Access Compliance Report

Public Rights-of-Way

(Curb Ramps)

Intersection ID: 48462	Main Street: PANGLEMONT_DR	Cross Street: MITZI_DEBORAH_LN	Location: SW
ADA ID: 525E7544890F	Ramp Type: Perp	Initial Pass/Fail: Fail	Overall Compliance: No
Severity Score: 10			
Codes/Mitigation Info/Possible Solution		Field Measurements/Component Compliance

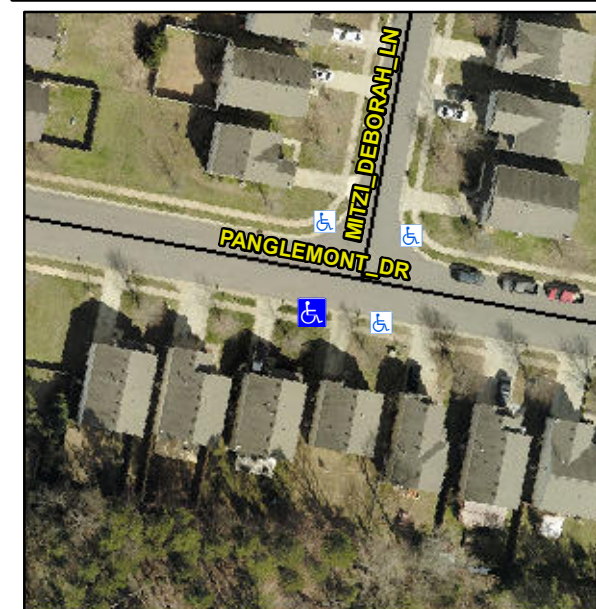
Not Found, R304.5.1, R304.5.3

Compliance	Description	Data	Compliance	Description	Data
N/A	Ramp Length (in)	47.0	Yes	Ramp Slope (%)	6.7
No	Ramp Width (in)	47.5	No	Ramp XSlope (%)	4.4
N/A	Flare Type LT	N/A	N/A	Flare Type RT	N/A
N/A	Flare Slope LT (%)	N/A	N/A	Flare Slope RT (%)	N/A
N/A	Flare Traversable LT?	N/A	N/A	Flare Traversable RT?	N/A
N/A	Landing Length (in)	N/A	N/A	DWS Provided?	N/A
N/A	Landing Width (in)	N/A	N/A	DWS Contrast?	N/A
N/A	Landing Slope (%)	N/A	N/A	DWS Length (in)	N/A
N/A	Landing X Slope (%)	N/A	N/A	DWS Full Width?	N/A
N/A	Landing Curb? (Y/N)	N/A	N/A	DWS Offset (in)	N/A
N/A	Shared Landing?	N/A			
N/A	Gutter Ponding?	N/A	N/A	Gutter Slope (%)	N/A
N/A	Gutter Lip Ht (in)	N/A	N/A	Gutter X Slope (%)	N/A
N/A	Painted X Walk1?	No	N/A	Painted X Walk2?	N/A
	X Walk 1 Direction	To N		X Walk 2 Direction	N/A
N/A	X Walk 1 Width (in)	N/A	N/A	X Walk 2 Width (in)	N/A
	X Walk 1 Slope (%)	2.9		X Walk 2 Slope (%)	N/A
	X Walk 1 X Slope (%)	4.0		X Walk 2 X Slope (%)	N/A

Remove & Replace Entire Ramp.
